**From:** [ELAYER Tina \\* DEQ](#)  
**To:** [rick.](#)  
**Subject:** RE: ECSI 6573 - Additional SI Request- Draft SAP Comments  
**Date:** Monday, March 25, 2024 9:48:00 AM  
**Attachments:** [image001.png](#)  
[2024-03-15 ECSI6573 SAP TE.pdf](#)

Lead worker reviewed the draft SAP and had the following comments.

Attached is the Sampling and Analysis Plan for additional investigation of Jerry's Clutch and Transmission (Former). Let me know if you need additional information.

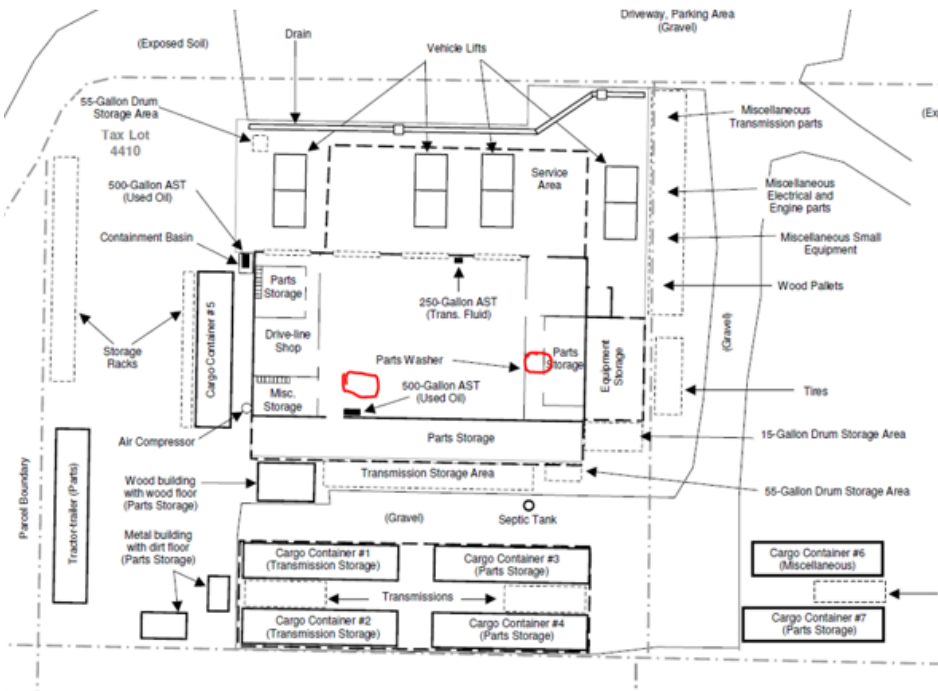
We suggest two locations (red circles) where data from soil vapor sampling would help us see if there is a risk, figure below:

Soil vapor samples should be analyzed for VOCs by Modified EPA Method TO-15. No duplicate required. The results will need to be compared to our recently updated vapor intrusion screening levels (VISLs). If these areas are covered by concrete slab, then sub-slab soil vapor samples could be collected. If there is no slab, then soil gas samples should be collected from approximately 5 feet bgs.
